TECHNICAL SERVICE BULLETIN

Technical Service Bulletin: 67-1311

Forest River is alerting you to an issue involving certain 2021 Shockwave and Sandstorm Toy Haulers. Please see the information below, which describes the issue and provides you with details on the steps you should take to have your vehicle repaired.

TECHNICAL SERVICE BULLETIN 67-1311 REMEDY INSTRUCTIONS

FIG – 5 Installed T-Connectors at Roof Power Feed

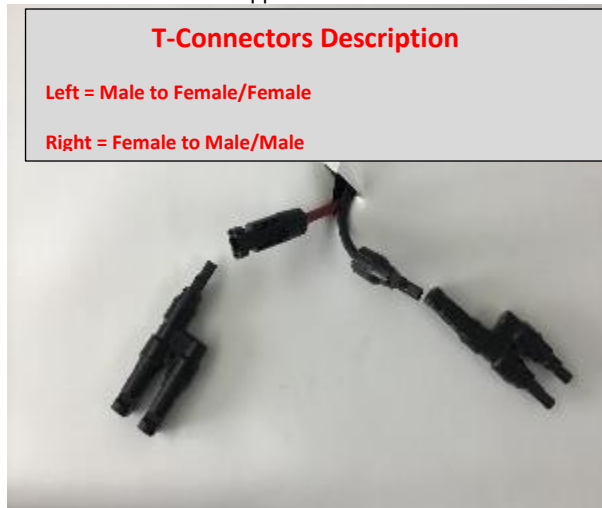
- Step 6. Install supplied t-connectors (1) male/female/female and (1) female/male/male t-connectors (FIG 4) to main power feed wires shown in (FIG 3). Ensure all new connections snap/lock in place. Perform a pull test at new connections. Newly installed t-connection should be installed as shown in (FIG 5);

Ensure T-Connections Snap & Lock in Place

FIG - 6 Final Connections Solar Panels Roof Power Feed

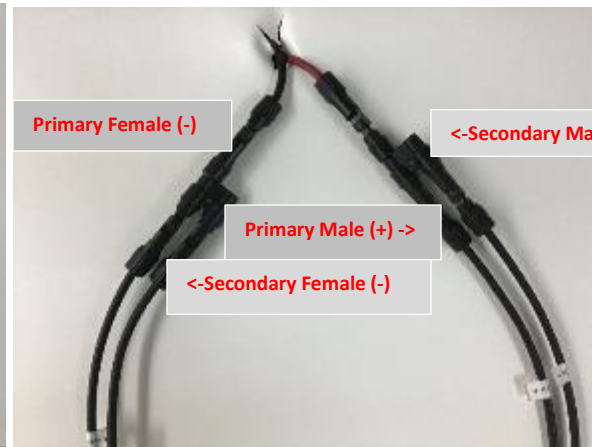
- Step 7. Connect Primary Solar Panel no#1 wire leads male/female panel wiring to t-connections male and female connections (FIG 6);
- Step 8. Connect Secondary Solar Panel no#2 wire leads male/female panel wiring to t-connections male and female connections (FIG 6) Included in the TSB parts kit contains 2 ea. 3' lead extension male/female pigtailed. Extensions can be used if wiring is not the able to reach the connections from secondary solar panel #2 to primary solar panel #1 that contain the t- connectors. (fig 7);
